**BOARD OF SUPERVISORS
PUBLIC HEARING
STAFF REPORT**

SUBJECT: ZRTD-2019-004, SPEX-2019-0037, SPEX-2019-0038 &
SPEX-2019-0039, Bles Park

Figure 1: Map of Bles Park showing area (orange hatching) where additional Phase I archaeological survey is recommended.

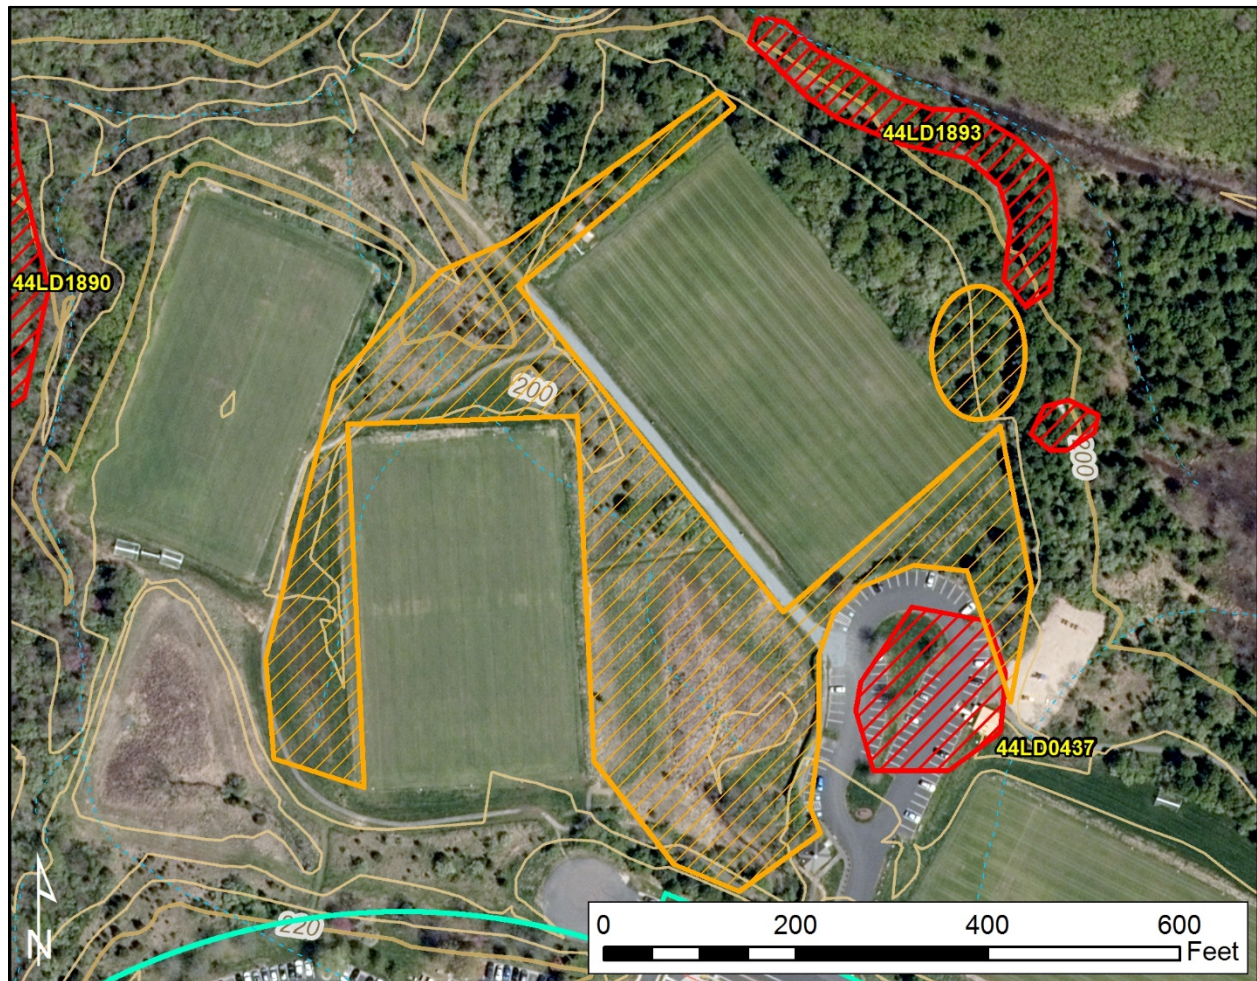
In staff's assessment, Thunderbird's Phase I survey does not provide adequate coverage of the area surrounding the existing parking lot and athletic fields, where the current CDP proposes significant new developments, including expansion of the parking lot as well as extensive hard surface path and pavilion construction. **Staff recommends that the applicant undertake additional Phase I testing in the area highlighted in orange hatching in Figure 1, below.** The goal of this additional testing is to clarify the extent, both horizontal and vertical, of disturbances associated with the existing parking lot and athletic fields and to determine whether potentially significant archaeological deposits survive in this area that will be impacted by planned improvements.

In summary, staff recommends that the applicant undertake additional Phase I survey within the area highlighted in Figure 1 as well as Phase II evaluation testing of the western portion of 44LD1895 prior to approval of this application. Staff also recommends a condition of approval requiring additional Phase I archaeological survey and, if necessary, Phase II and Phase III investigations if the refinement of

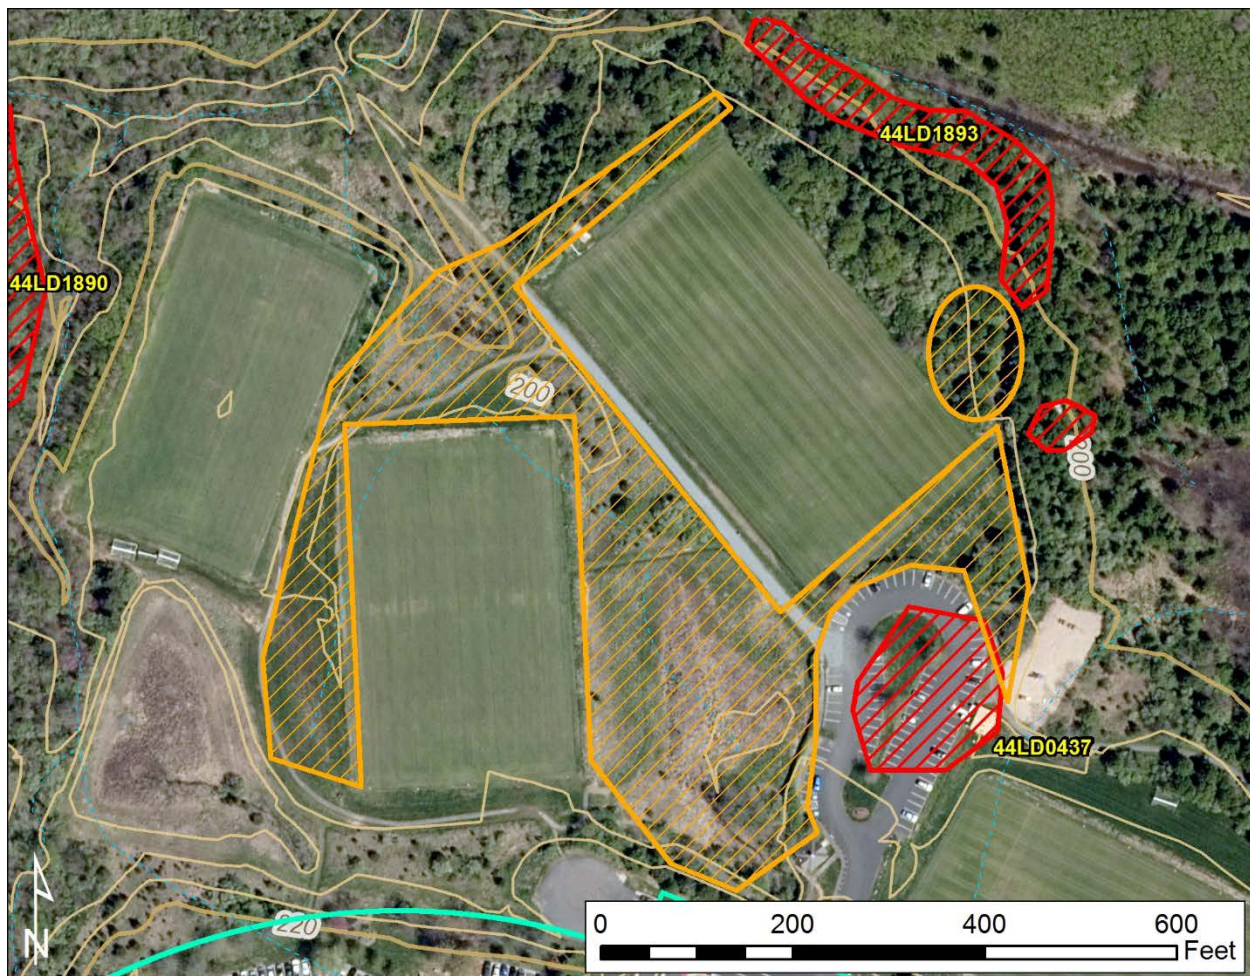
construction. Staff recommends that the applicant undertake additional Phase I testing in the area highlighted in orange hatching in Figure 1, below. The goal of this additional testing is to clarify the extent, both horizontal and vertical, of disturbances associated with the existing parking lot and athletic fields and to determine whether potentially significant archaeological deposits survive in this area that will be impacted by planned improvements.

Comment 7: In summary, staff recommends that the applicant undertake additional Phase I survey within the area highlighted in Figure 1 as well as Phase II evaluation testing of the western portion of 44LD1895 prior to approval of this application. Staff also recommends a condition of approval requiring additional Phase I archaeological survey and, if necessary, Phase II and Phase III investigations if the refinement of construction plans following approval of this application imposes unforeseen impacts to previously unsurveyed areas and/or to previously identified historic resources.

Response: Comment acknowledge and will be incorporated in the conditions of approval as noted in comment response #1.
